ACCESSIBILITY PERFORMANCE SOLUTION REPORT

16 WYATT AVENUE, BELROSE

27TH JUNE 2022

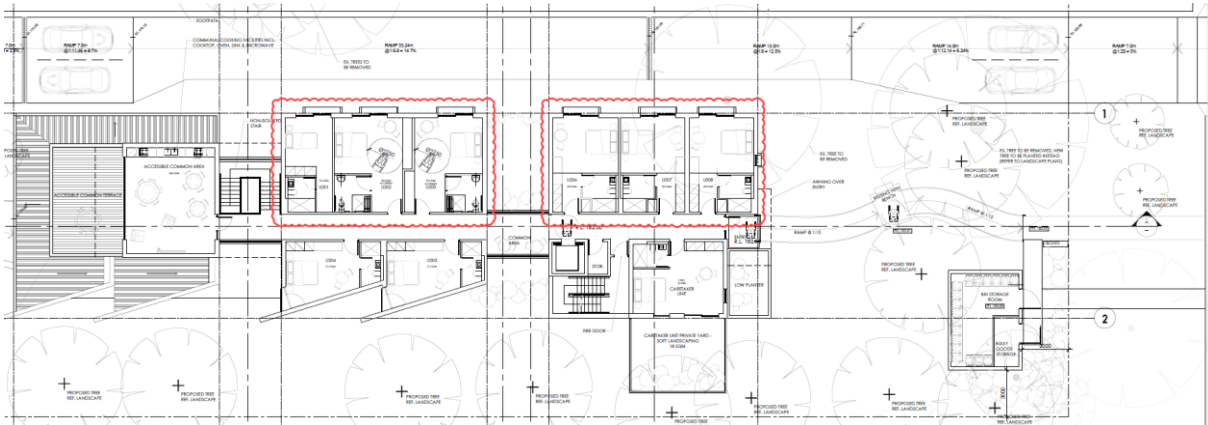
9. **Upper Building** - The Upper Level Building proposes 1:14 ramped access from the Wyatt Avenue front boundary that arrives at the principal entrance @RL182.00 which has appropriate doorway circulation spaces in accordance with ASI428.1 (2009) to satisfy clause D3.2 of the NCC 2019 Amdt 1.

10. Internally, the plans show a 1600mm minimum width corridor to two (2) accessible units, common dining/lounge room, outdoor terrace and a lift to the lower ground floor and basement carpark which incorporates two (2) accessible parking spaces. The common corridor includes a 1800mm width area for passing while the circulation stair can be detailed with handrails and other features in accordance with ASI428.1 and ASI428.4.1. Overall, the access to and within the common areas on the ground floor of the upper building comply with clauses D3.2, D3.3, D3.5, D3.8 and E3.6 NCC 2019 Amdt 1.

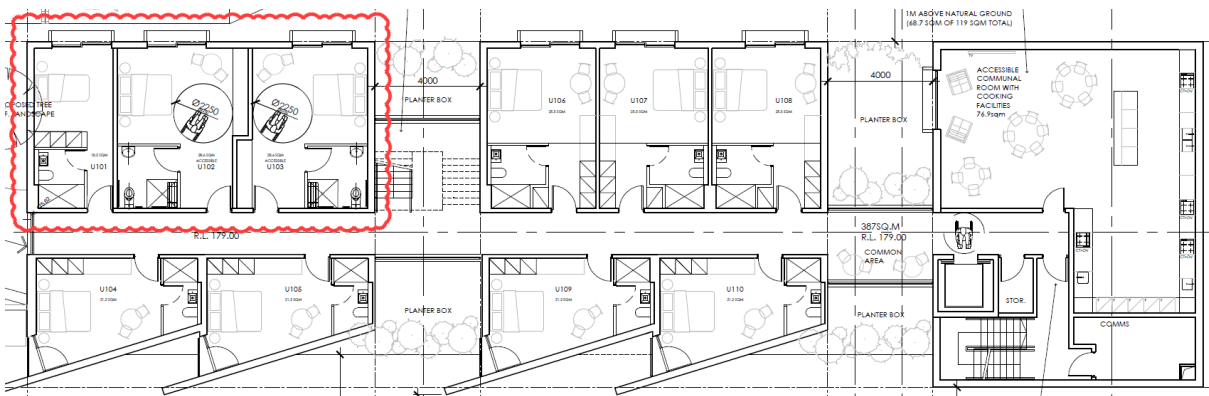
11. The lower ground floor of the upper building provides a similar layout with a 1600mm minimum width corridor from the lift to two (2) accessible units, common dining/lounge room and an outdoor terrace. Overall, the access to and within the common areas on the lower ground floor of the upper building comply with clauses D3.2, D3.3, D3.5, D3.8 and E3.6 NCC 2019 Amdt 1.

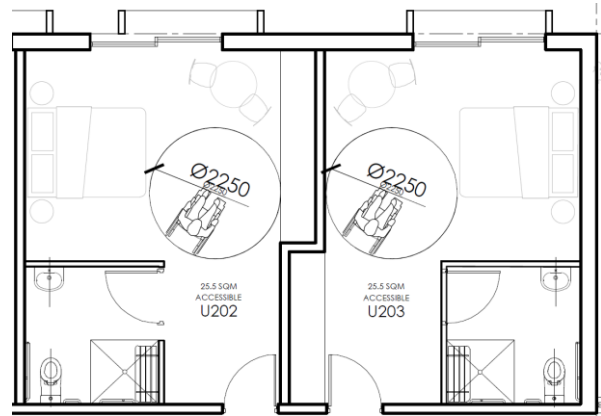
13. With respect to the interior design of the four (4) accessible units the plans show ample doorway circulation spaces to enter the room, circulate around three sides of a queen bed and access a bathroom.
14. Currently, the bathrooms indicate an area of 2250mm X 2400mm and with a minor adjustment to 2400mm X 2400mm and alternate layout will fully comply with ASI428.1 to satisfy clause F2.4 of the NCC 2019 Amdt 1.
